ART AND ARCHITECTURAL REVIEW BOARD (AARB)

Research Data Center – Building B1324
Fontaine Research Park, University of Virginia

AARB Final Review

April 10, 2026

Proposed Aerial View

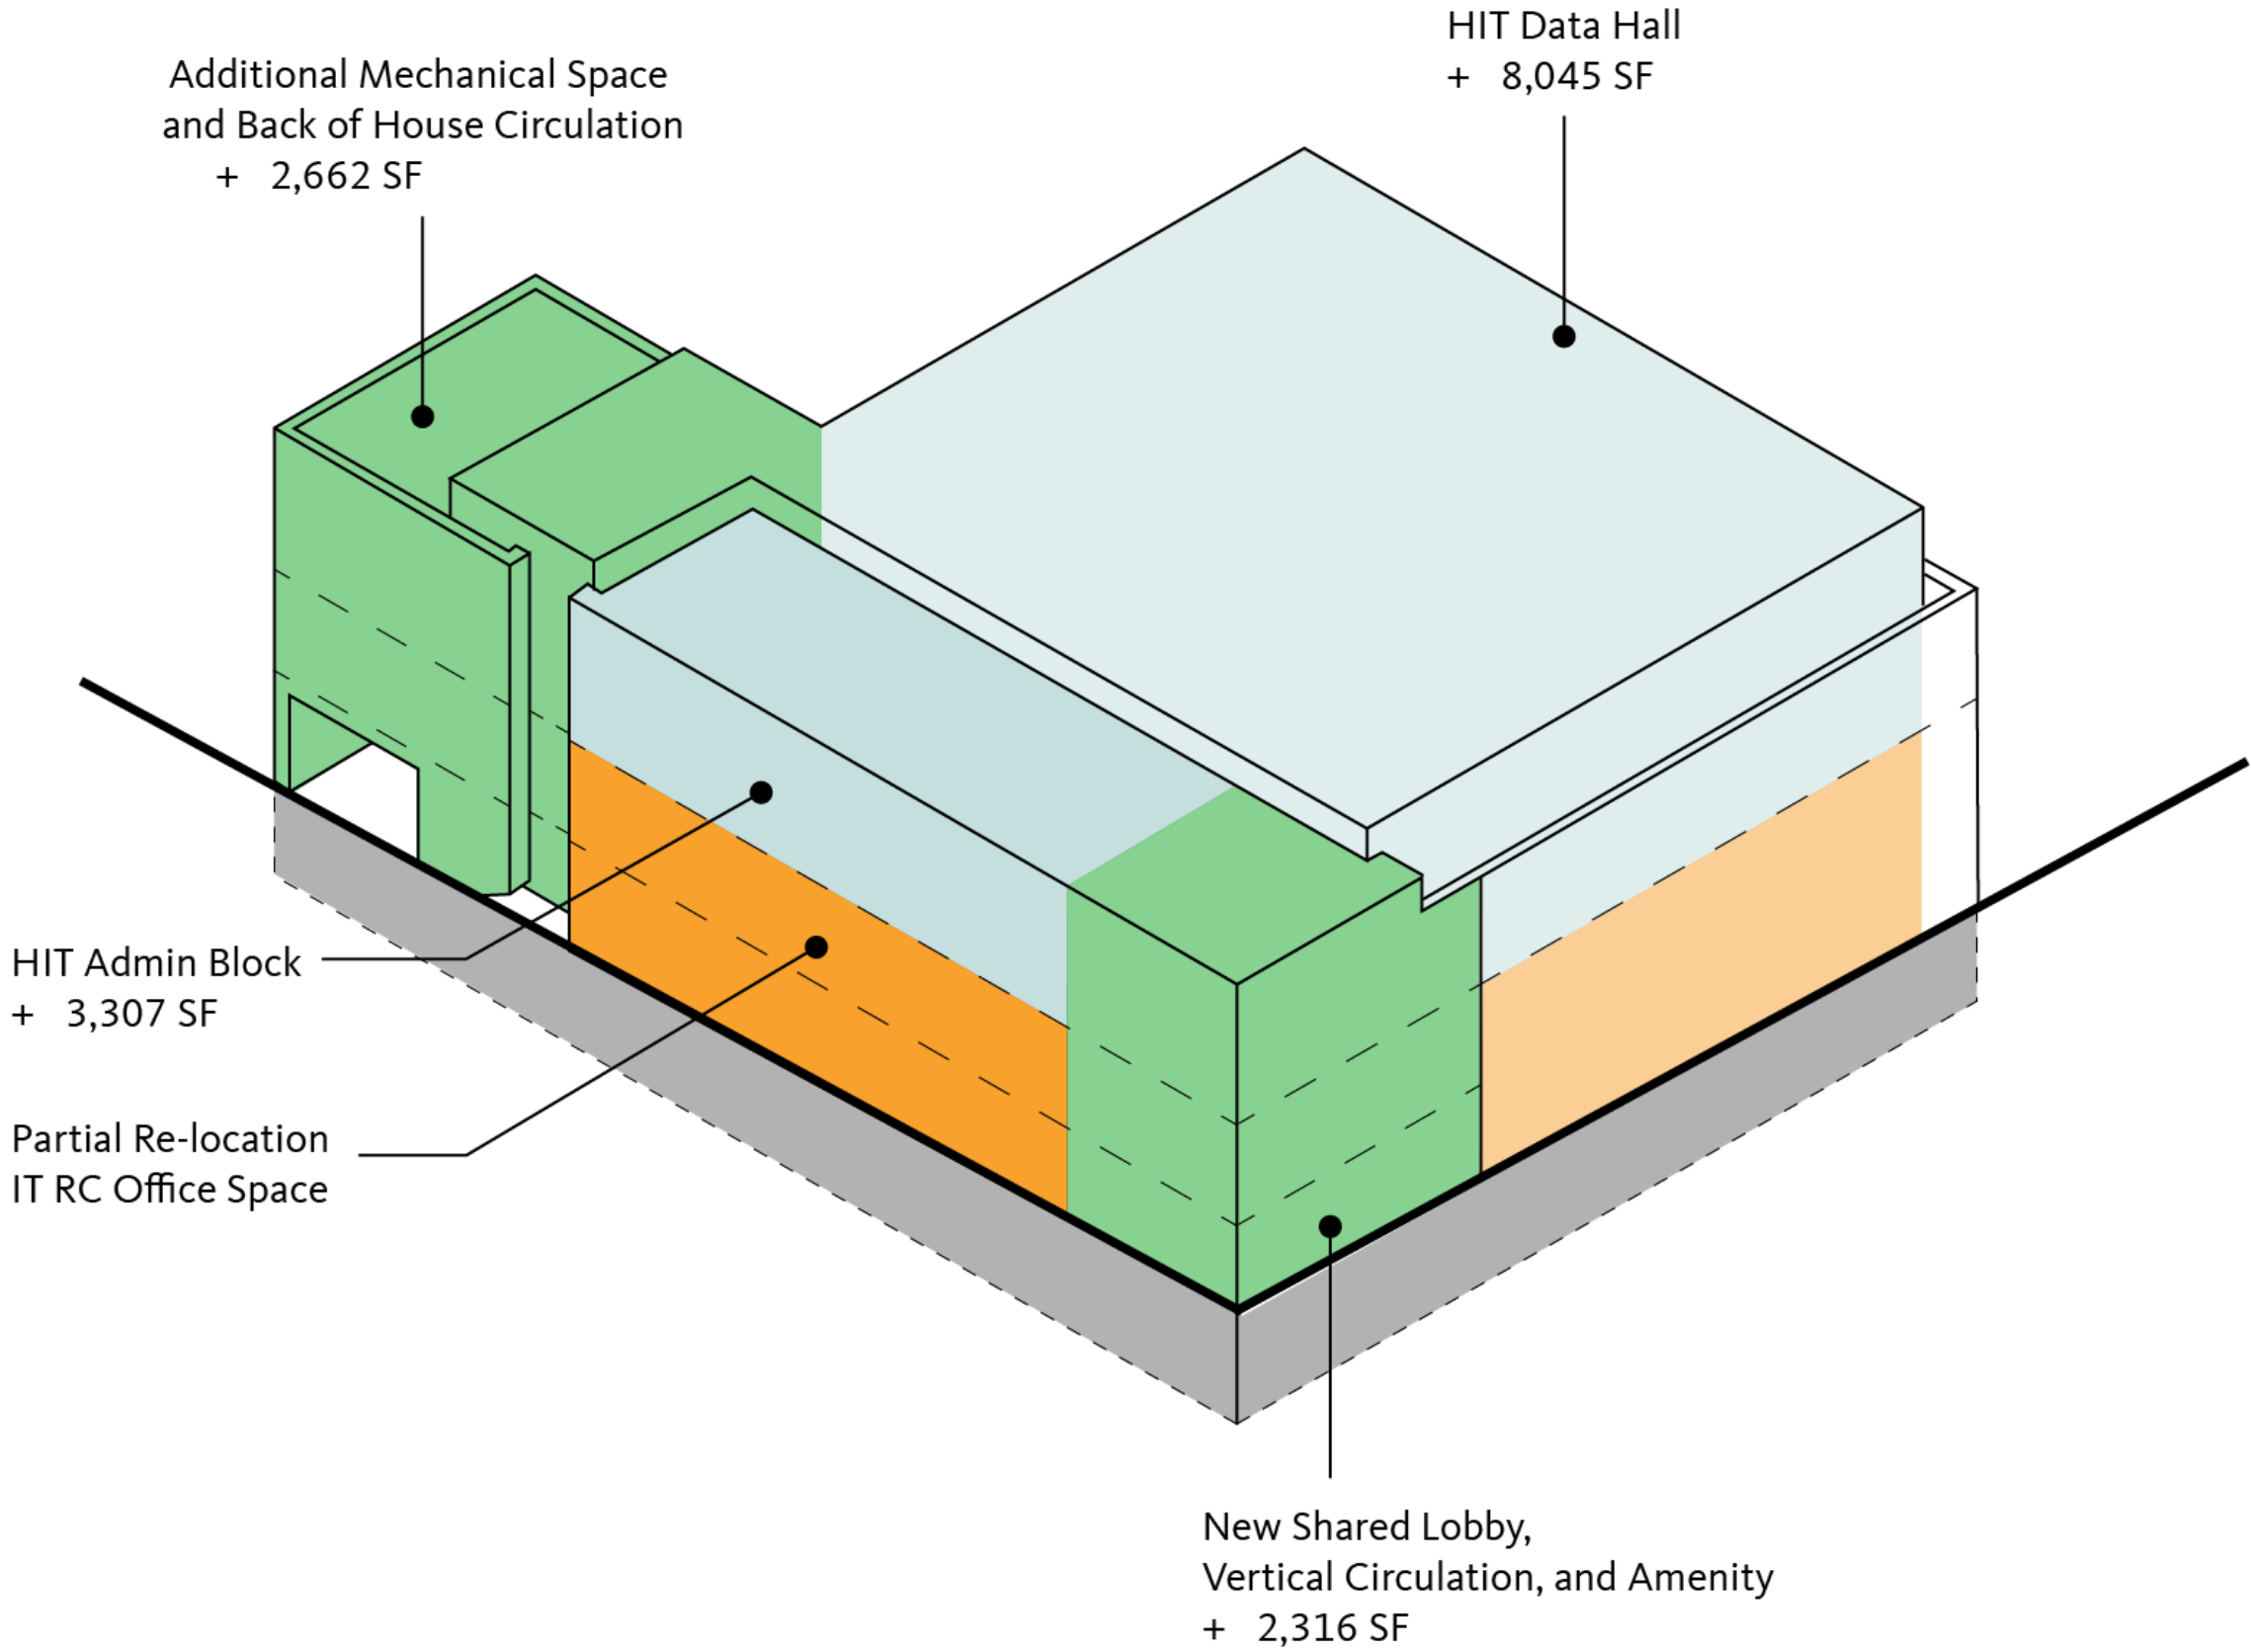
- Restate previous Board comments.
 - Consider tying in design elements from surrounding buildings, specifically the Swiss Coffee coloring.
 - Explore ways to further obscure on-site utilities from view.

- The on-site utilities are primarily isolated to the equipment yard, which is both behind the building, and at a lower elevation to the primary grade at which most of Fontaine is inhabited. Further screening is provided by landscape planting, visible in the landscape plan diagram.

Architecture | Material Palette

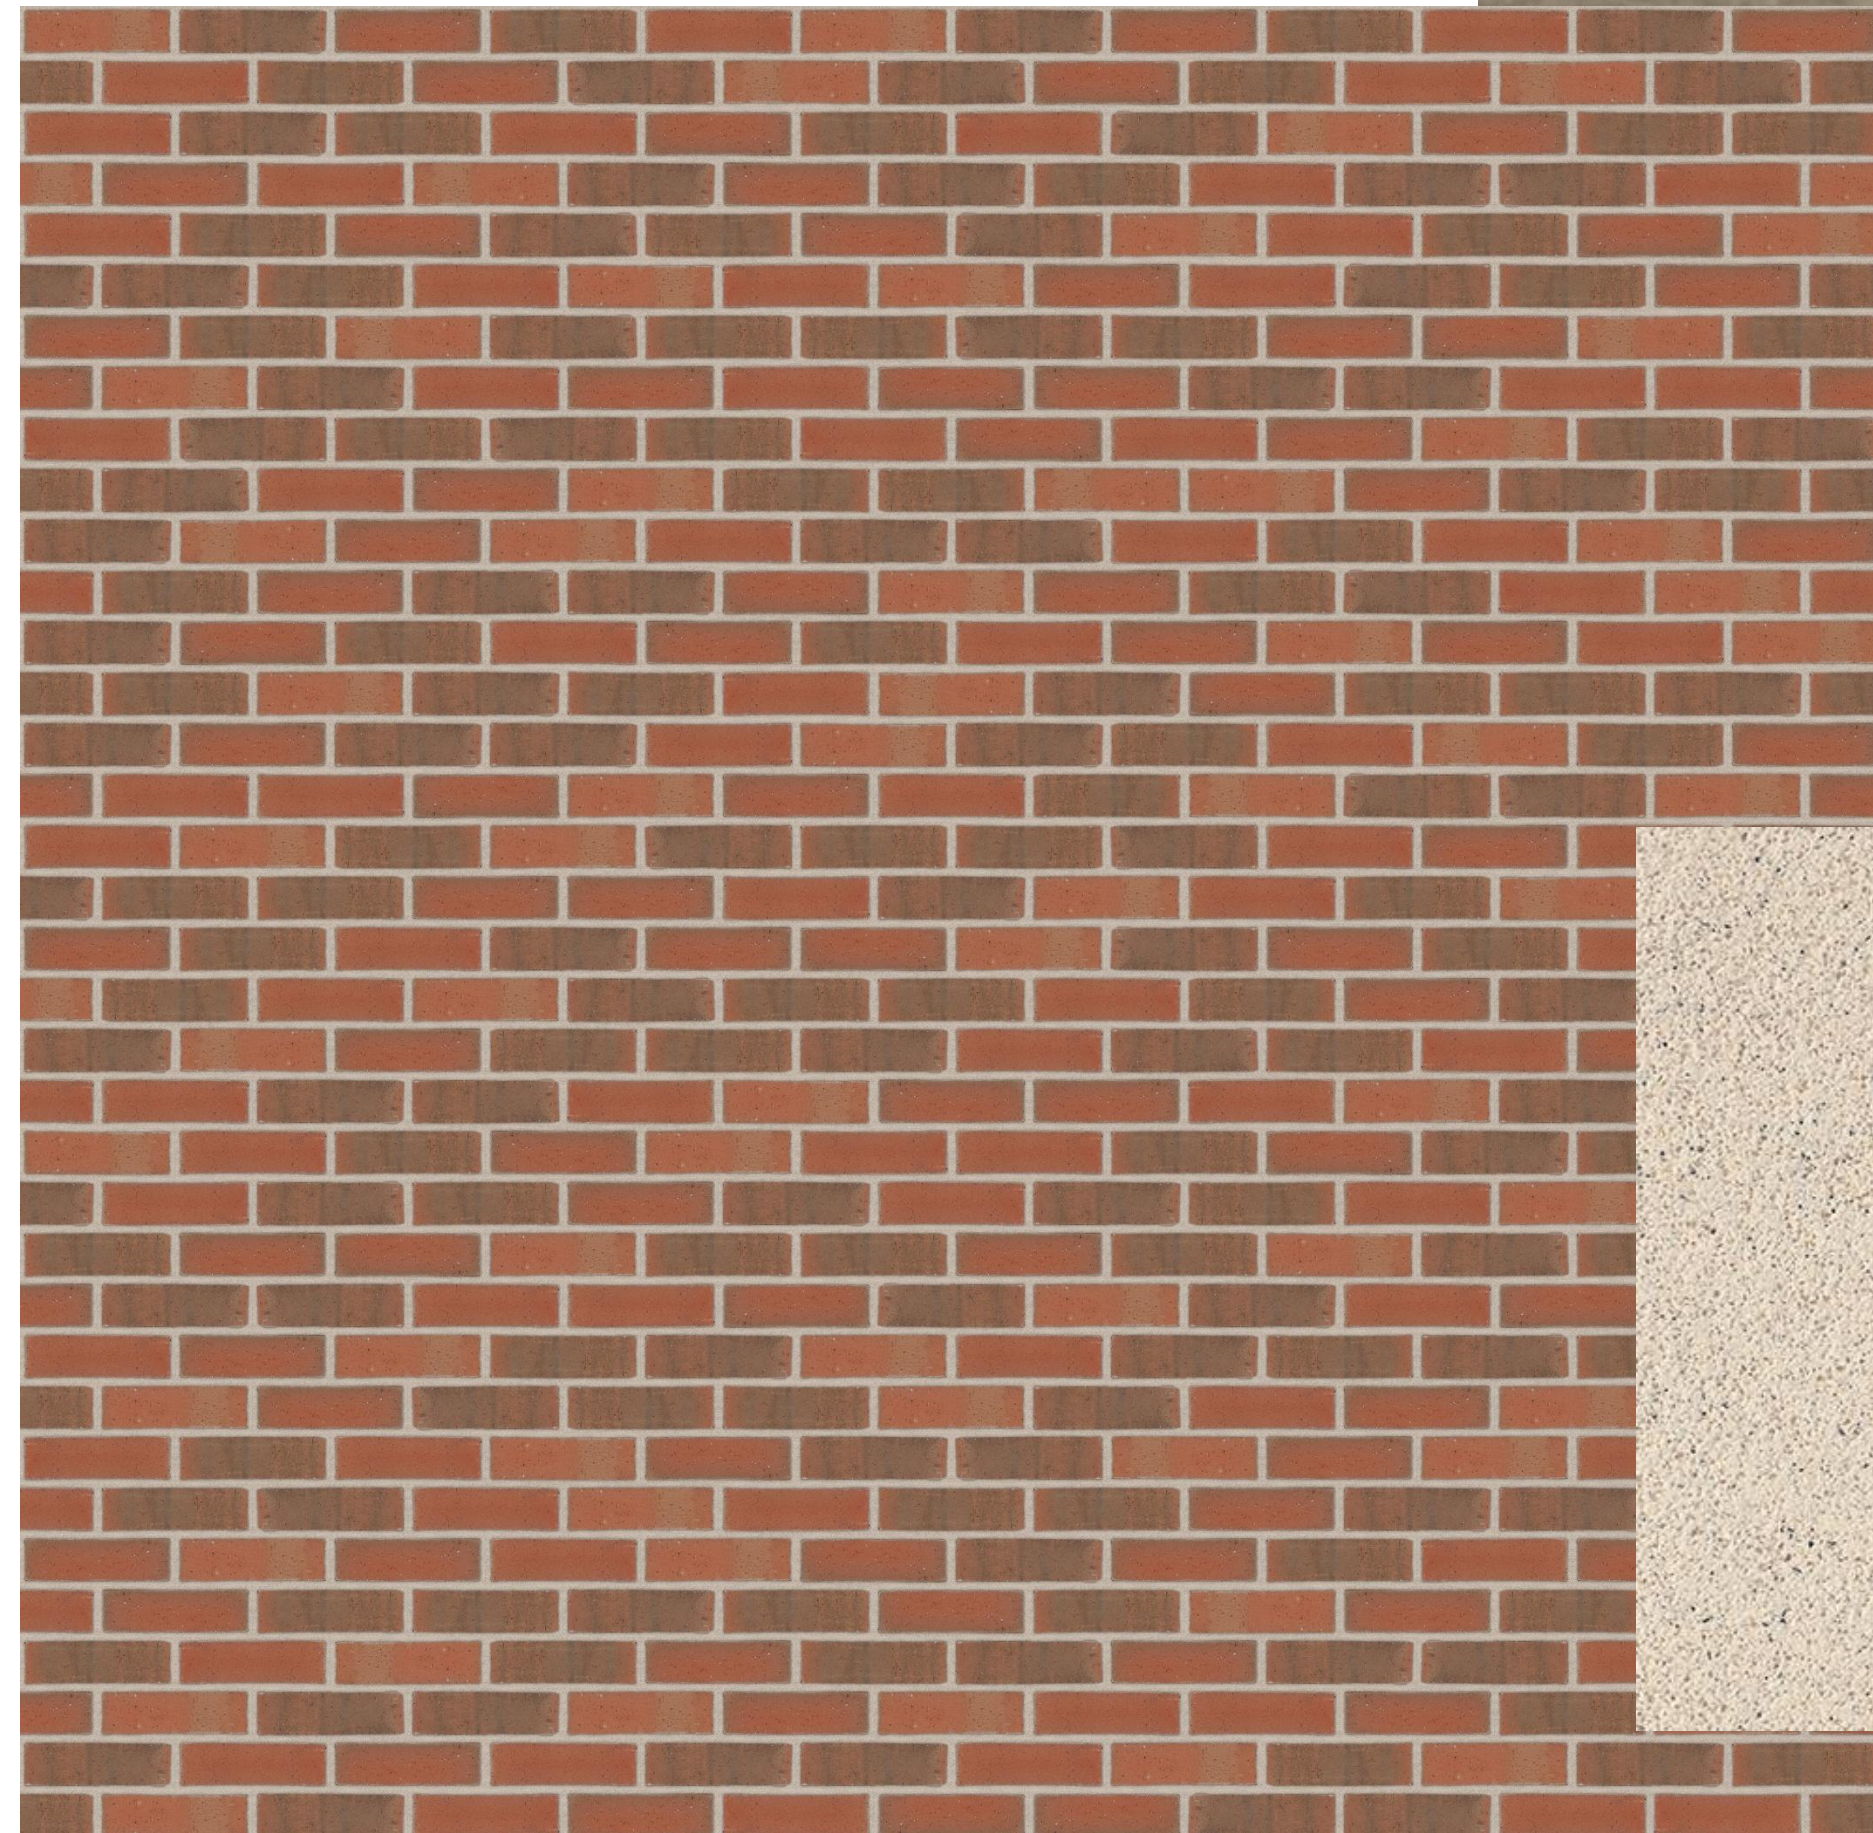
- Provide material and color samples for the final presentation.
- Show actions taken to address Board comments; use visuals to compare previous renderings with updates.

Swiss Coffee Precast Concrete

Building Entry Pedestrian Experience

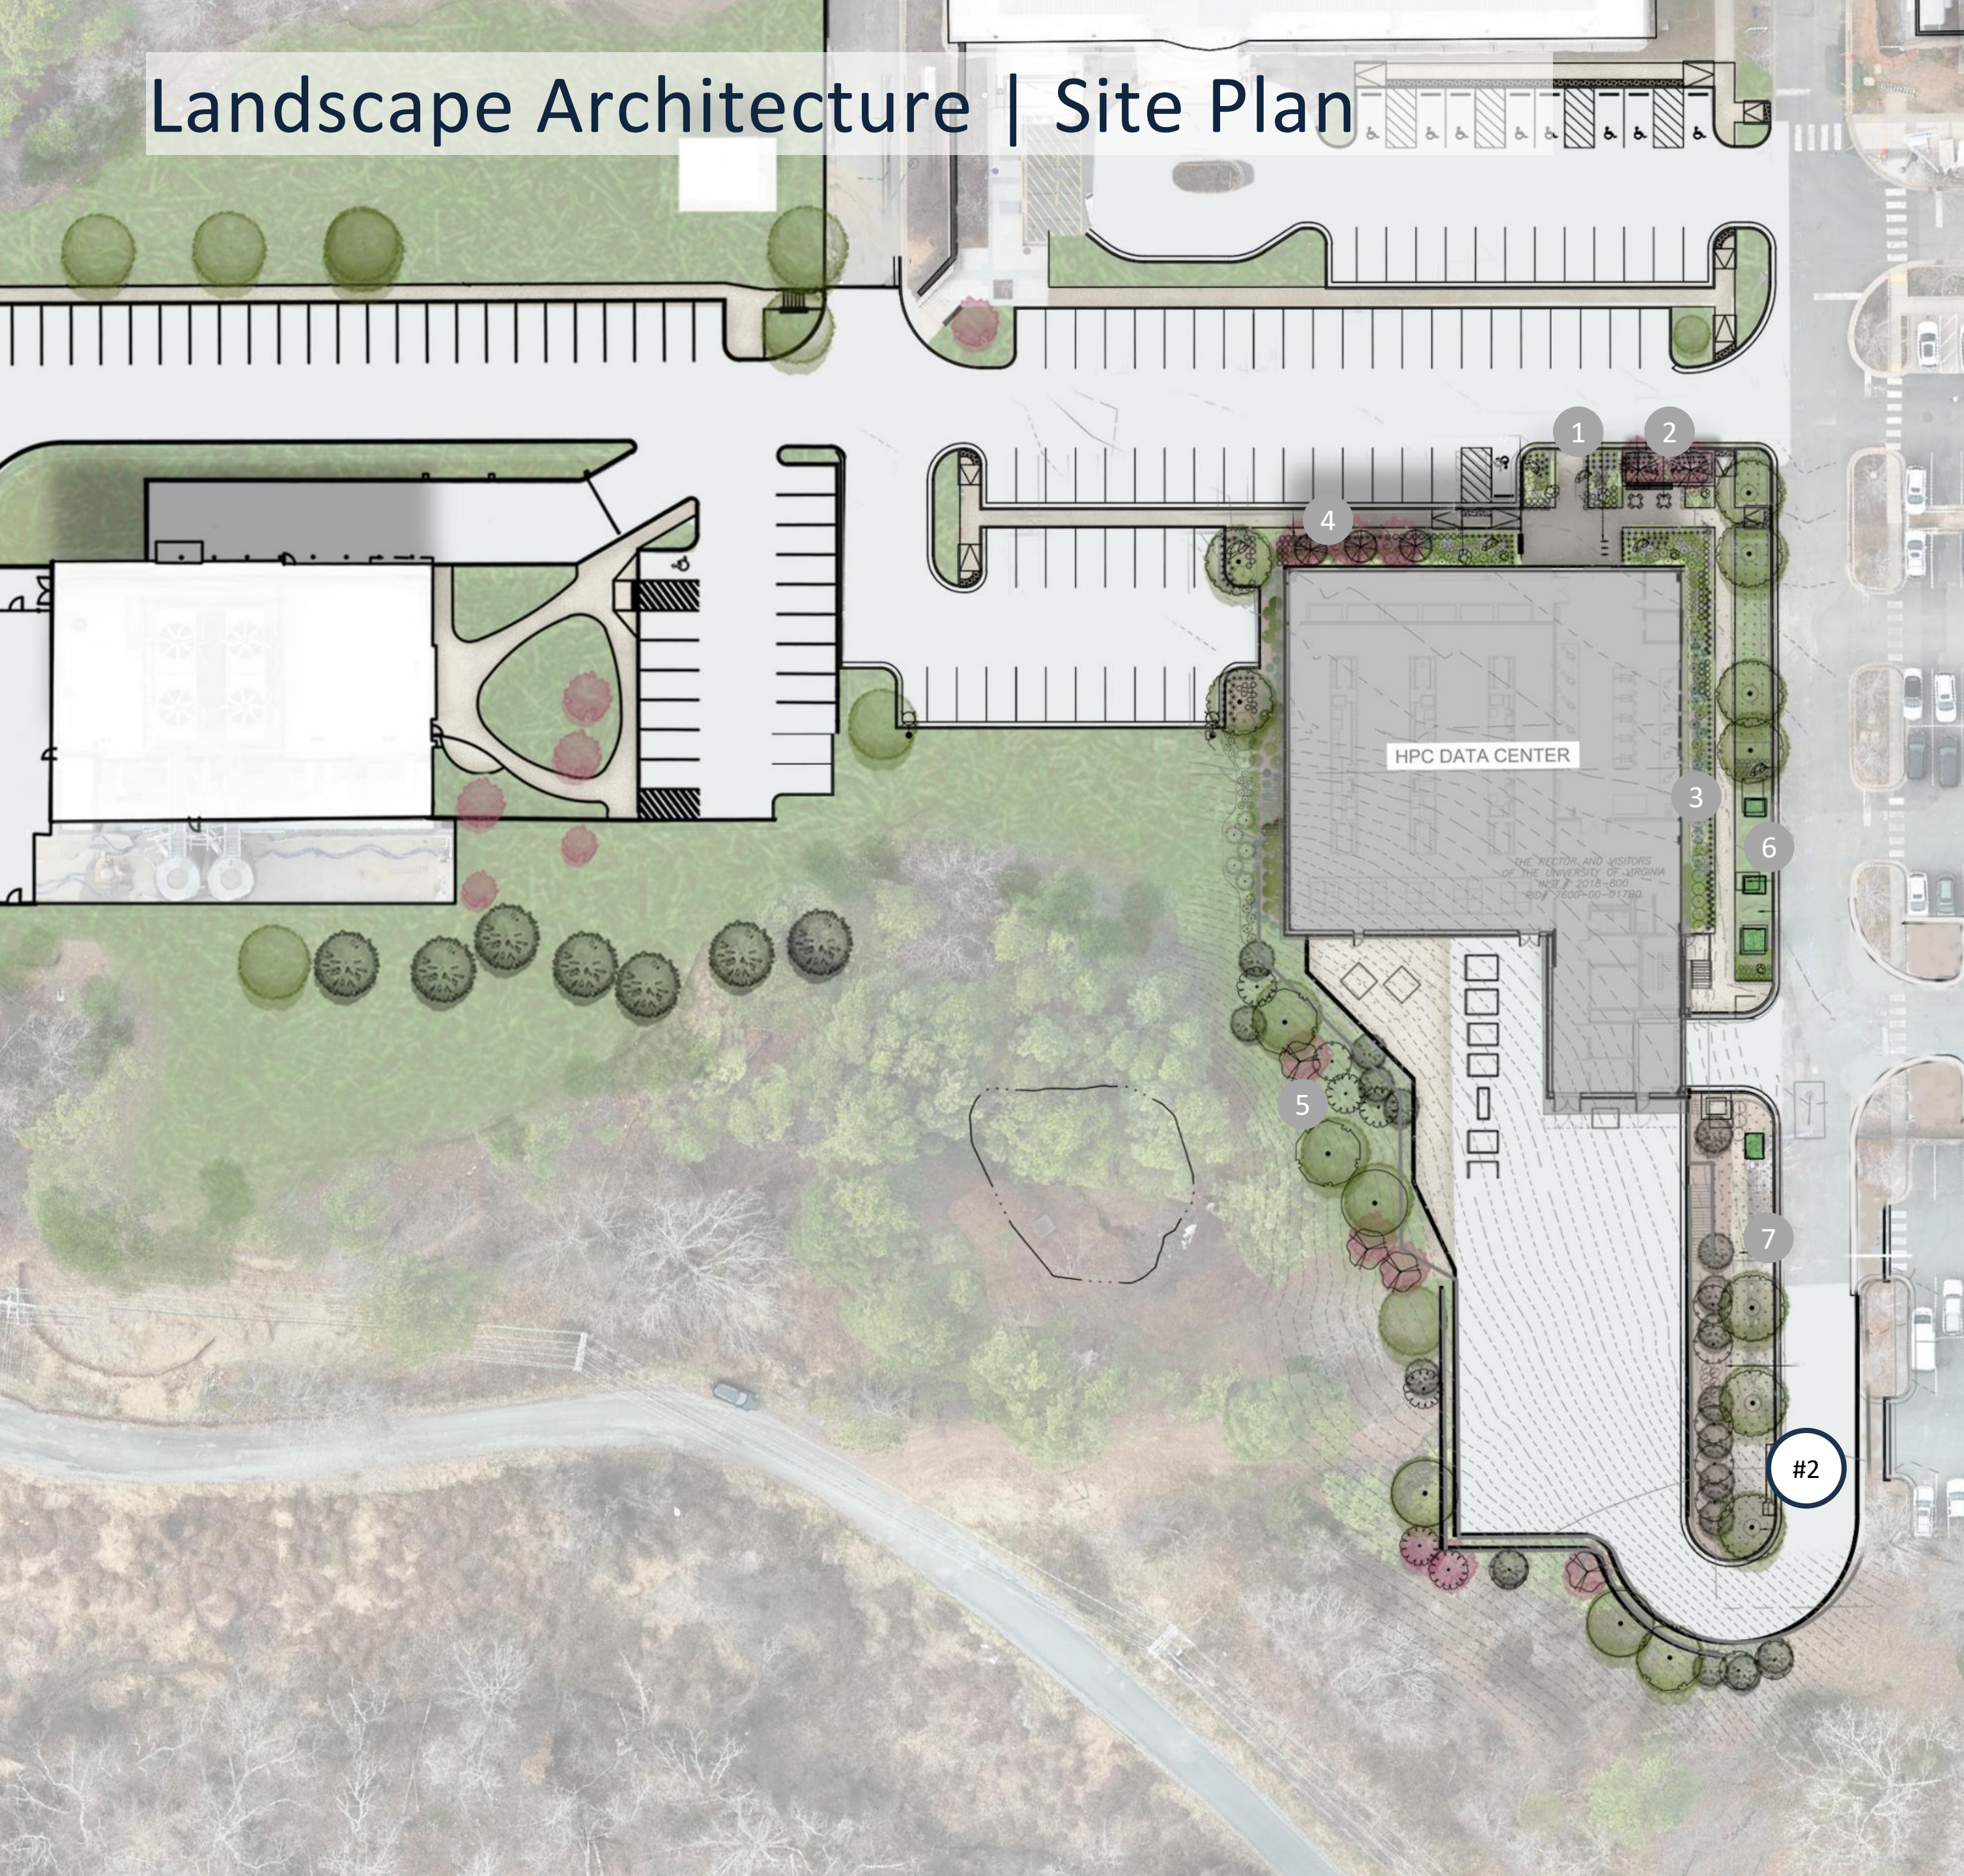
- Look into signage options that highlight the building's sustainability efforts.
 - Include further renderings from the pedestrian's view.
 - Explore ways to clarify the hierarchy of the entrances.

- The parklet zone at the front entry provides space where informational signage could be incorporated to highlight the building's sustainability efforts. If the budget allows, interior and exterior signage will be incorporated to explain the systems and distribution technology.

- At the secondary stair, the break in brick has been scaled down to match the front entry so that it does not take precedence. The canopy at the front entry, its proximity to the amenity program inside the building, and connection to the parklet outside give prominence and a sense of arrival.
